## Field Safety Notice

Reference: R546

This voluntary Field Safety Notice (FSN) is to inform you about a Field Safety Corrective Action (FSCA) for the AR-9800 Synergy RF Console.

New label

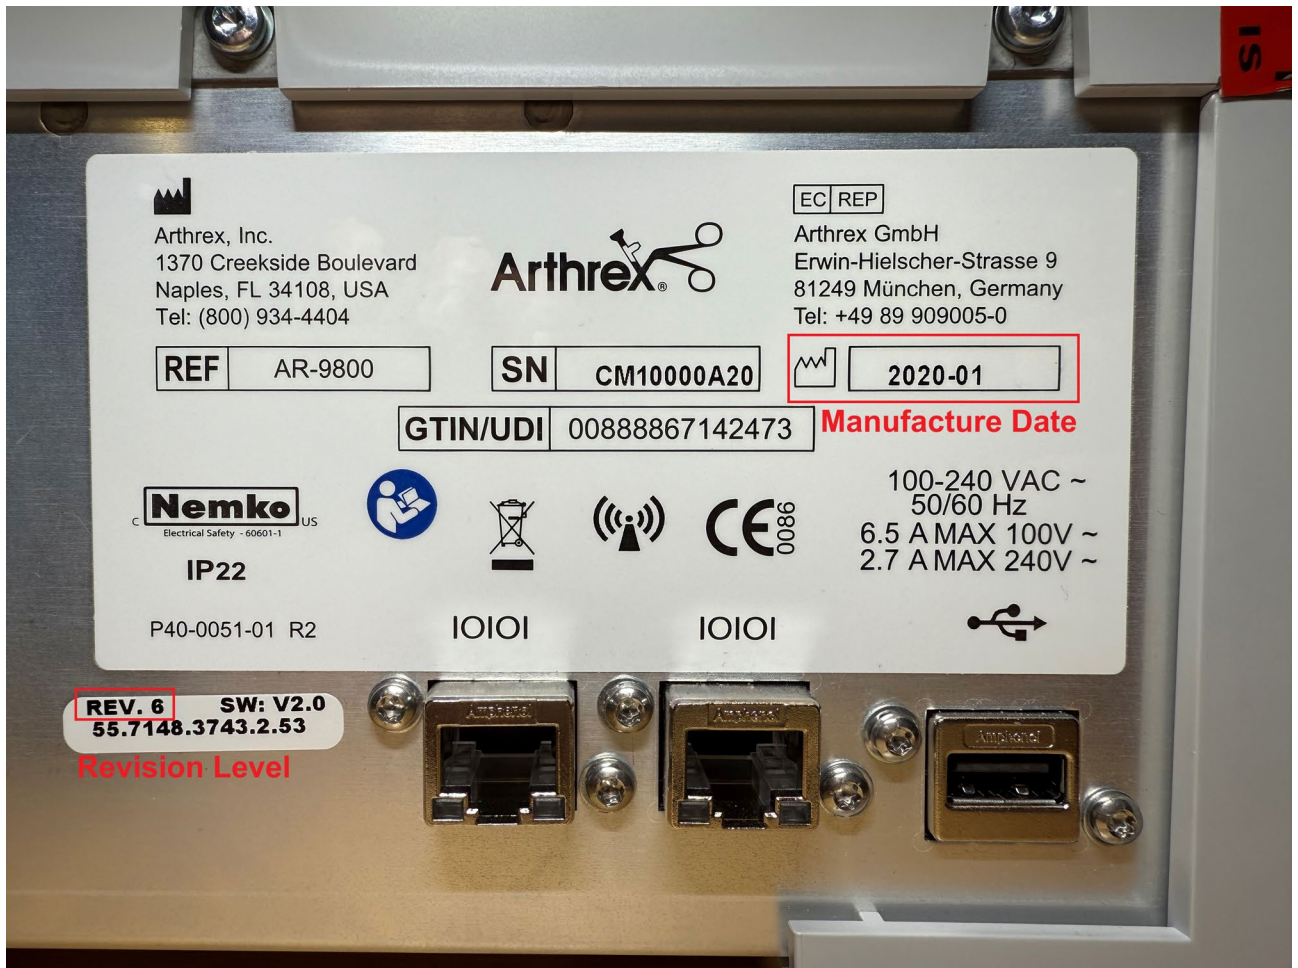
Upon initial power up of the AR-9800 there is a potential, with some electrical services, that an inrush current may occur. If this inrush current is to occur, there is a possibility that the circuit breaker trips. If the breaker trips, resetting the circuit breaker will be required to restore power. Other devices connected to the same electrical circuit would experience a temporary power outage until the circuit breaker is reset or the devices are connected to another power circuit.

To resolve this issue, an Arthrex employee will replace the current T8A fuses with new F4A fuses and relabel the device with new fuse specifications.

1. Immediately identify the indicated AR-9800 you have in your control. The affected devices can be identified via a label on the back of the device that indicates the revision level (see picture below). If the revision level label is not present, the device should be considered affected if the manufacturing date is prior to July 2020. The manufacturing date is indicated on the main label on the back of the device.
